ATTACHMENT B

PROJECT: Rockville Pike (MD355)/Cedar Lane/West Cedar Lane Intersection
SHA Contract No. MO5935270
Mandatory Referral No. MR2010806

Proposed Configuration

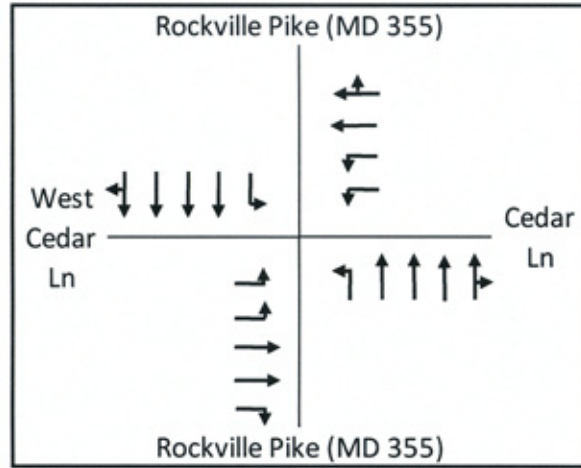
Intersection: No crosswalk would be provided on the south leg of the Cedar Lane/West Cedar Lane intersection.

Two segments of proposed sidewalk on either side of MD355 just north of Cedar lane are adjacent to the curb, as is the short segment of sidewalk on West Cedar Lane just west of the intersection. These segments do not meet the AASHTO recommendation to be two feet wider where immediately adjacent to the roadway curb. A 170-foot-long segment of the proposed shared use path on the north side of Cedar Lane just east of the intersection similarly does not meet this recommendation.

AASHTO recommends that a pedestrian refuge island be considered where the crossing distance is greater than 60 feet. The crosswalk on West Cedar Lane is 88 feet; the crosswalk on Cedar Lane is 68 feet. Both exceed AASHTO's guidance.

As noted above, the crosswalks on the west and east legs of the intersection exceed AASHTO guidance for the provision of pedestrian refuges. The Cedar Lane leg is slightly over the recommended distance at 68 feet versus the AASHTO recommended 60 feet. The West Cedar Lane crosswalk is 88 feet long. While it would be desirable to have these pedestrian refuges, accommodating them would adversely affect the design of the stormwater management pond at the northwest corner of the intersection if the alignment of the through lanes is to be maintained. Therefore, we will forego a recommendation to provide these refuges.

The sidewalk in the northwest quadrant of the intersection along MD355 is proposed immediately adjacent to the roadway curb. AASHTO recommends that such sidewalks be two feet wider to provide a greater measure of pedestrian safety and comfort, but it would be necessary to increase the length of the two proposed retaining walls because of the adjacent tall slope. The walls in turn would trigger additional guidance that the sidewalk be widened by another two feet to account for the tendency of people to shy away from lateral constraints. Given the difficulties of construction at this location, we will forego a recommendation to widen the sidewalk beyond the standard five feet.

No crosswalk currently exists on the south leg of MD355 at Cedar/West Cedar and none is proposed. This creates a problem for pedestrians and off-road bicyclists travel on West Cedar Lane traveling to the NNMC campus since the nearest gate is at North Wood Road, where there is no existing or proposed crosswalk. These users would either have to cross the other three legs of this large intersection or travel more than 500 feet down to the signalized crosswalk at Wilson Lane and backtrack. We recommend that a crosswalk be provided on the south leg of MD355 at Cedar Lane/West Cedar Lane or that a pedestrian-actuated signal be provided to stop traffic in both directions at the proposed half-signal at North Wood Road. The latter option would have the advantage of allowing off-road bicyclists to stay on a shared use path until they are ready to cross MD355.

Since the roadway is proposed to be widened, it would generally move closer to the reconstructed shared use path. But between Wilson Drive and the NIH Commercial Vehicle Inspection Facility, two segments of the shared use path are proposed to be moved closer to the *centerline* of the roadway, meaning that while the curb line is moving west, the path would also move east.

While the existing path meanders, the proposed path would be offset at a consistent five feet from the curb. We recommend instead that the slope of the landscape buffer between the path and the curb be increased to 4:1 in this area so that a greater offset of the path can be achieved.

Where sidewalks are adjacent to the curb, we recommend that they be two feet wider per AASHTO recommendations. Where the path along Cedar Lane is adjacent to the curb, we recommend that it be ten feet wide minimum; but where it is located between the curb and the culvert parapet, we recommend that it be twelve feet wide minimum. The Cedar Lane path is located adjacent to the curb beyond the project limits also and will be part of the mitigation package for Park impacts (see below).

The Master Plan recommends trees on both sides of Rockville Pike between the curb and sidewalk/path and in the median, but the proposed project has none. Very few shade trees are proposed and all are behind the sidewalk/path. No ornamental trees or shrubs are proposed between the curb and sidewalk/path or in the median, with the exception of a cluster of six ornamental trees in the median just south of Locust Hill Road. All other landscaping is behind the sidewalk/path.

The width of the landscape buffer is generally at least five feet, and while not ideal, is sufficient room to plant shade trees between the curb and sidewalk or path. We recommend that this be done. As recommended above, there are locations where a greater offset of the path from MD355 can be provided; the wider buffers would also make it easier to plant shade trees.
